June 28, 2019
Project No. SL10793-2

Spanish Vineyards
285 Bridge Street
San Luis Obispo, California 93401

Subject: **Engineering Geology Evaluation of Roadway Alignment**
Driveway to Proposed Residence, APN: 079-251-005
Pismo Beach Area, San Luis Obispo County, California

Sheets Site 1 and Site 2 – Spanish Vineyard Residence

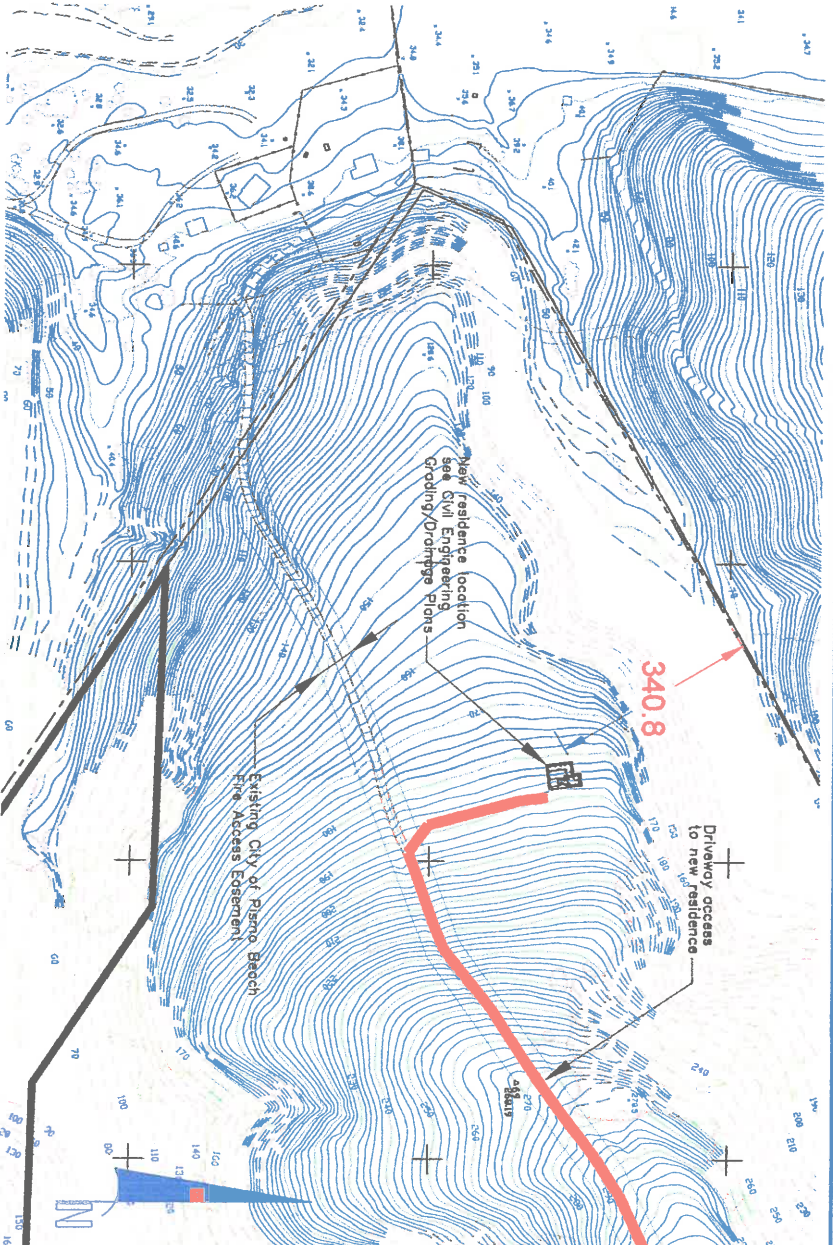
This report includes the results of our engineering geologic review of the project site plan for the driveway improvements for the Spanish Vineyard residence, APN: 079-251-005, in the Pismo Beach Area of the County of San Luis Obispo, California. The purpose of our review was to confirm the referenced plan was in compliance with the intent of the geologic recommendations provided in this Report and with known site conditions. Our review was conducted based upon Plan Sheets listed in Table 1.

It is our opinion that the proposed plans as listed in Table 1 is in general conformance with the intent of the recommendations presented in this Report.
